# Access Compliance Report

## Public Rights-of-Way

### (Curb Ramps)

Intersection ID: 7561	Main Street: LEMS福德_WY	Cross Street: REMFORD_CT	Location: SW
ADA ID: 0BEF314248BE	Ramp Type: Perp	Initial Pass/Fail: Fail	Overall Compliance: No
Severity Score: 1.25			
Codes/Mitigation Info/Possible Solution		Field Measurements/Component Compliance

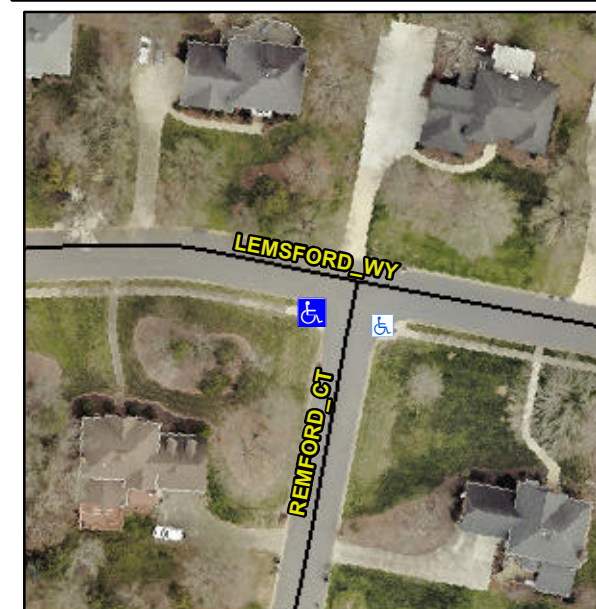
**Not Found, R304.5.3**

Compliance	Description	Data	Compliance	Description	Data
N/A	Ramp Length (in)	27.0	Yes	Ramp Slope (%)	7.7
Yes	Ramp Width (in)	48.0	No	Ramp XSlope (%)	4.5
N/A	Flare Type LT	N/A	N/A	Flare Type RT	N/A
N/A	Flare Slope LT (%)	N/A	N/A	Flare Slope RT (%)	N/A
N/A	Flare Traversable LT?	N/A	N/A	Flare Traversable RT?	N/A
N/A	Landing Length (in)	N/A	N/A	DWS Provided?	N/A
N/A	Landing Width (in)	N/A	N/A	DWS Contrast?	N/A
N/A	Landing Slope (%)	N/A	N/A	DWS Length (in)	N/A
N/A	Landing X Slope (%)	N/A	N/A	DWS Full Width?	N/A
N/A	Landing Curb? (Y/N)	N/A	N/A	DWS Offset (in)	N/A
N/A	Shared Landing?	N/A			
N/A	Gutter Ponding?	N/A	N/A	Gutter Slope (%)	N/A
N/A	Gutter Lip Ht (in)	N/A	N/A	Gutter X Slope (%)	N/A
N/A	Painted X Walk1?	No	N/A	Painted X Walk2?	N/A
	X Walk 1 Direction	To SE		X Walk 2 Direction	N/A
N/A	X Walk 1 Width (in)	N/A	N/A	X Walk 2 Width (in)	N/A
	X Walk 1 Slope (%)	1.4		X Walk 2 Slope (%)	N/A
	X Walk 1 X Slope (%)	6.7		X Walk 2 X Slope (%)	N/A

**Remove & Replace Entire Ramp.**
